Technical Service Bulletin (TSB)
Global Telematics Box Module (TBM) Firmware Over The Air (FOTA) Software Update from 5.43, 5.39 and 5.34 to 5.49

REFERENCE:	TSB: 08-223-24 GROUP: 08 - Electrical	Date:	November 15, 2024	REVISION:	–
VEHICLES AFFECTED:	2023 - 2024 (GC) Alfa Romeo Tonale 2023 - 2024 (GG) Dodge Hornet This bulletin applies to vehicles equipped with a Global Telematics Box Module (Sales Code RDG).			MARKET APPLICABILITY:	
				<input checked="" type="checkbox"/> NA	<input type="checkbox"/> MEA
				<input type="checkbox"/> SA	<input type="checkbox"/> IAP
				<input type="checkbox"/> EE	<input type="checkbox"/> CH
CUSTOMER SYMPTOM:	Customers may experience one or more of the following: <ul style="list-style-type: none"> • Remote door lock and unlock commands sent from the mobile app fail. • After saving the edited charge or climate schedule in the radio, the mobile app reverts it back to the schedule set on the mobile app. • Remote operation ignition on remote start not working. • Customer not receiving a monthly email containing the VHR (Vehicle Health Report).

**Fig. 1**

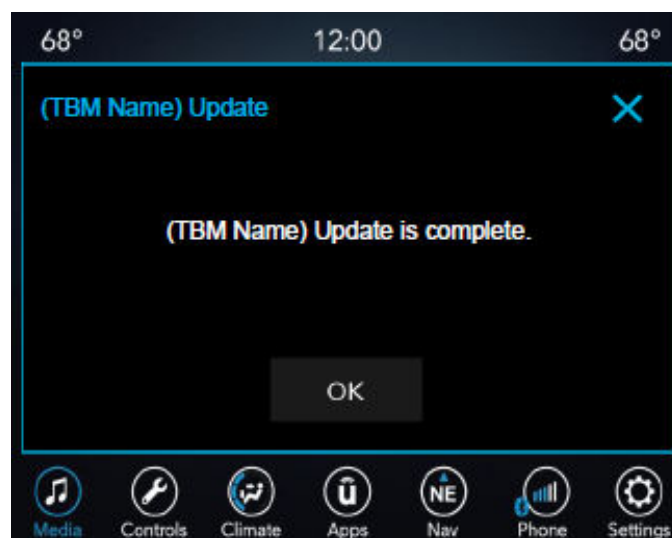
1. The vehicle needs to be in 'Park'. The ignition needs to be in the off position.
2. If the customer selects "Update Now" they can shut off the vehicle and leave. The update will be completed automatically.
